CONTRACT CHANGE ORDER

CCO: 43 **Suppl. No. 0** **Contract No. 04 – 0120F4** **Road** SF-80-13.2/13.9 **FED. AID LOC.:**

- Revise lighting pole and main tower lighting fixture schedules.
- Revise luminaire pull boxes and associated conduit routing into pull boxes.
- Add in-line fuses to luminaires.

Modify deck mounted lighting brackets.

480 V LIGHTING POLE 2

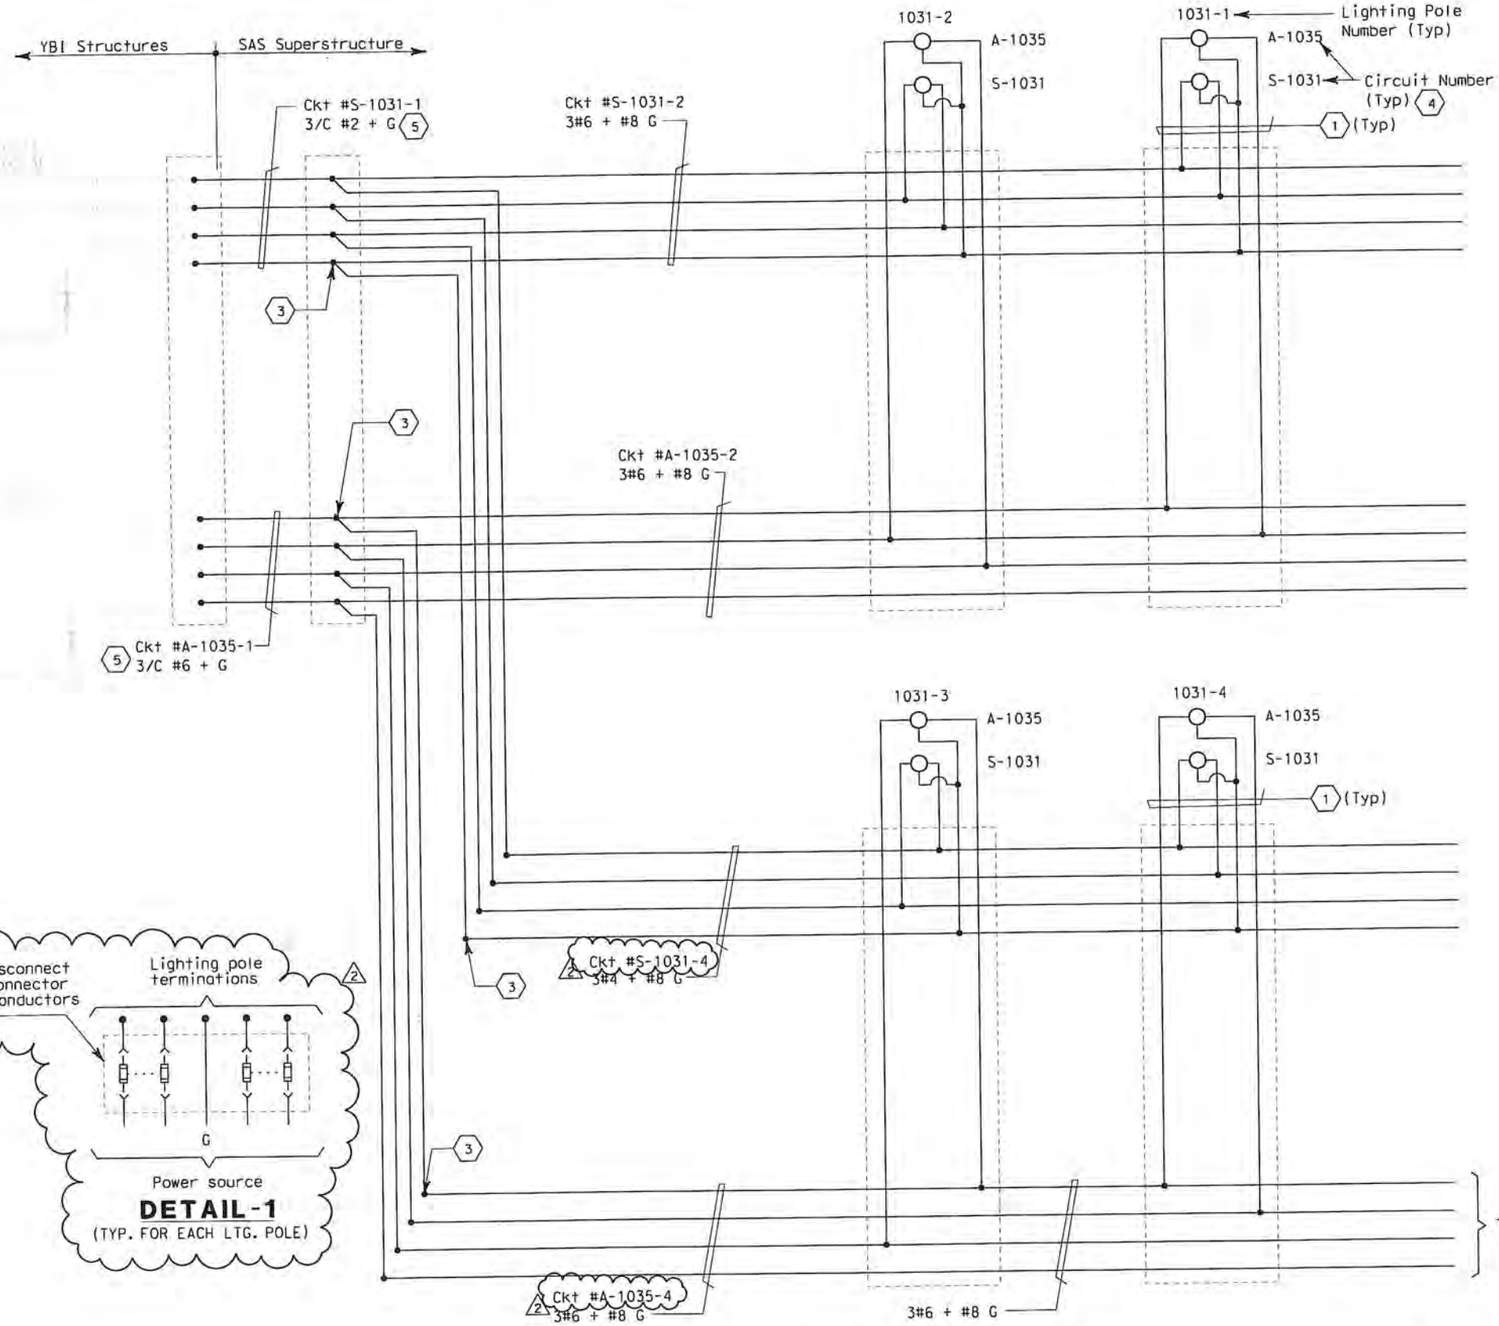
1. 4#10 + #10 G single conductors. See Detail 1. 2
2. Deleted.
3. Conductors spliced inside junction box PB-2A located inside girder.
4. For SAS Superstructure roadway westbound lighting schedule, see sheet E-82.
5. The Contractor shall extend and coil 5 meters of cable in manhole 25. All cables shall be tagged with circuit numbers as shown. For location of manhole 25, see sheet E-11.
2 6. Install 10A (ckt S-1031) and 5A (ckt A-1035) in-line fuse inside each light pole.

SAS SUPERSTRUCTURE CONDUIT - PLAN

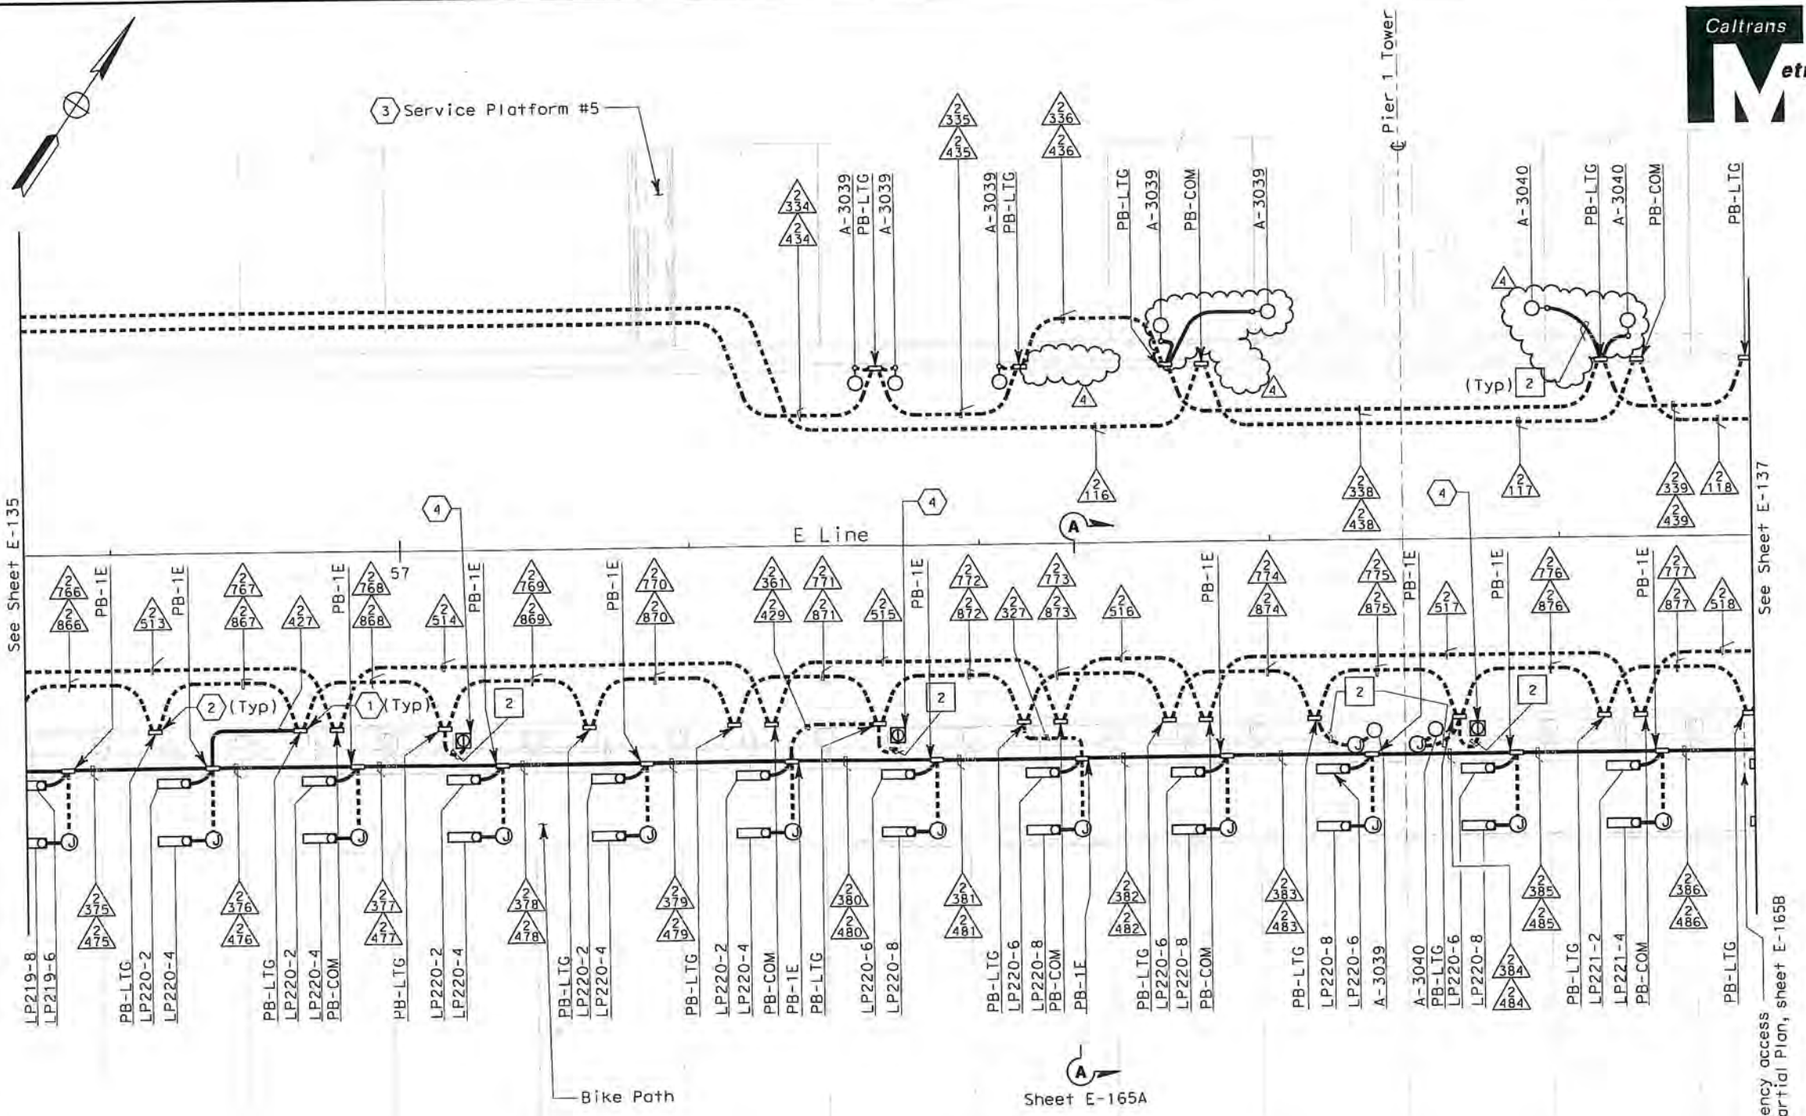
1. Conduit from barrier pullbox or other equipment down into Girder Box, see sheet E-182.
2. For conduit to tower and suspension cable lighting see sheet E-227.
3. Contractor shall furnish and install UP-205 and LP-220 per sheet E-72. For complete scope of work on platform and other related work not shown on this sheet, see Electrical Special Provisions.
4. Roadway Barrier Receptacle, see Detail 1, sheet E-162.

480 V MAIN (1) TOWER LIGHTING

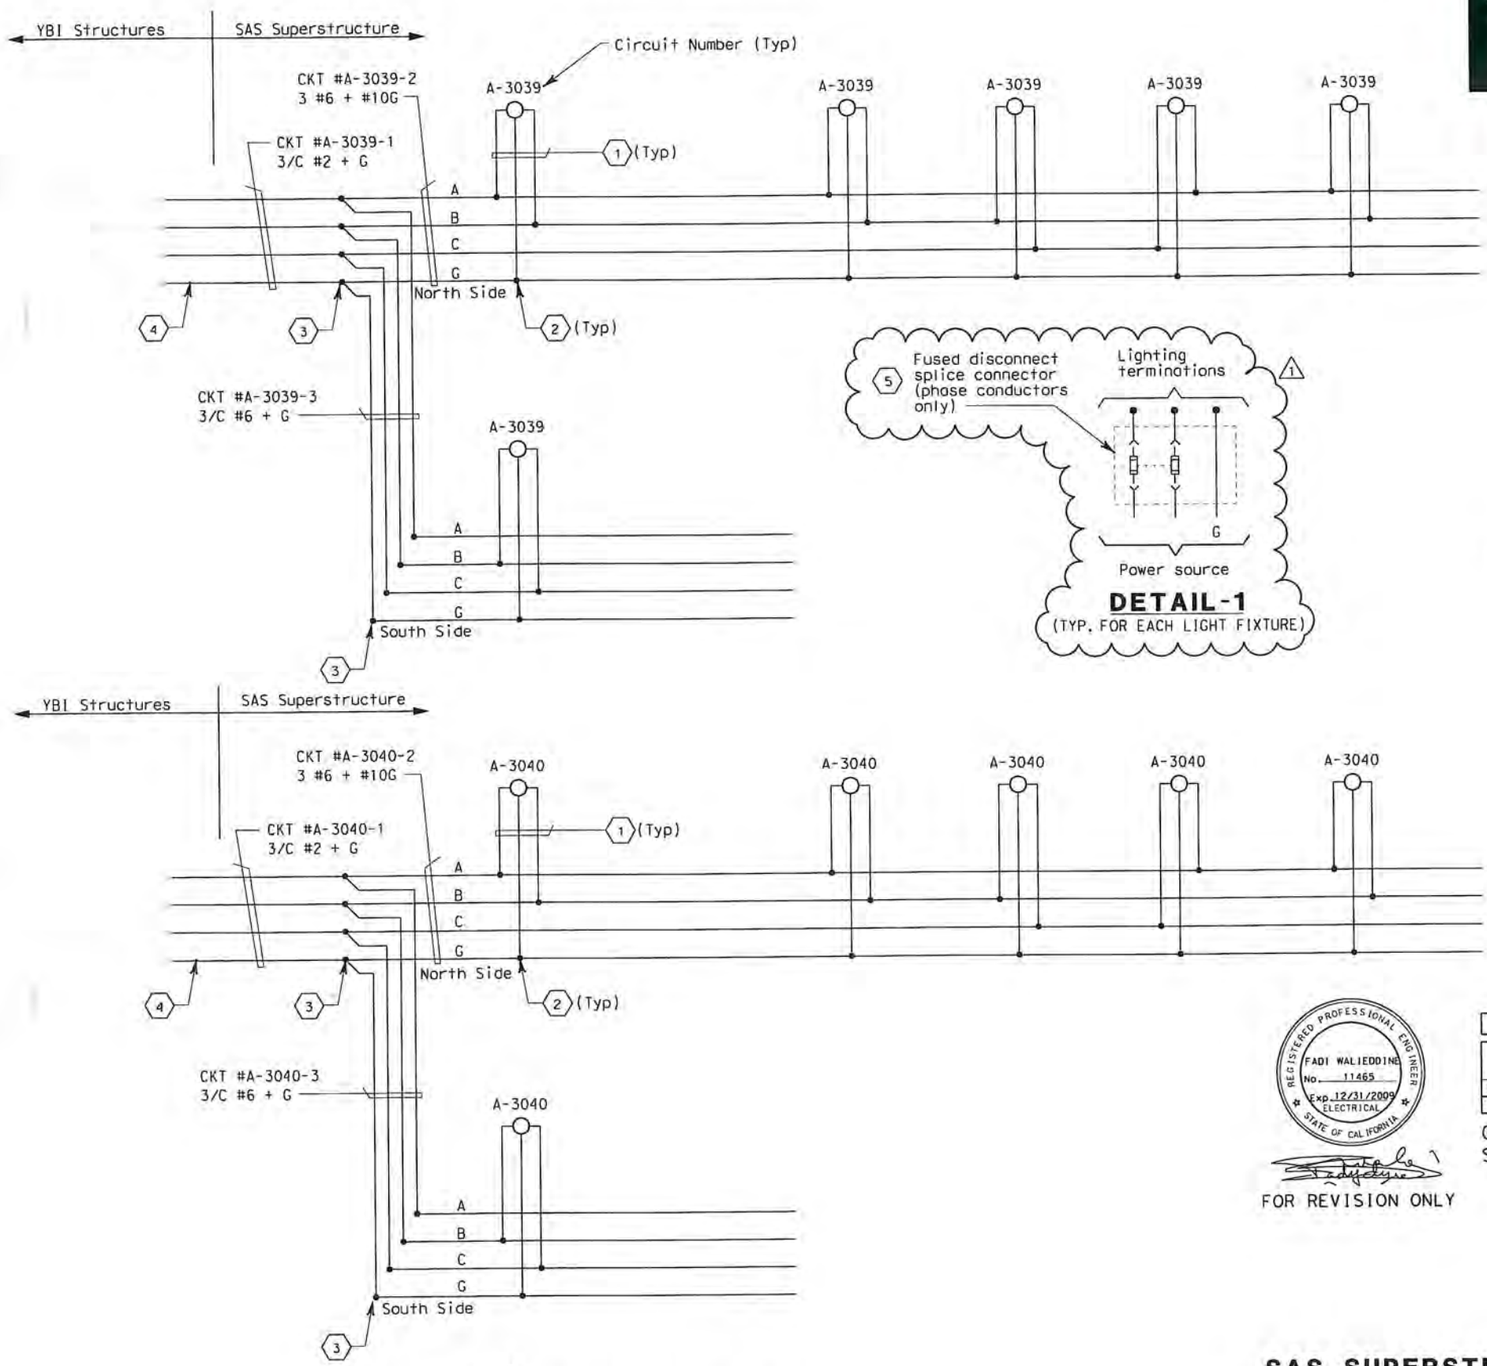
(1) 2#10 + #10 G single conductors. (1) See Detail 1.
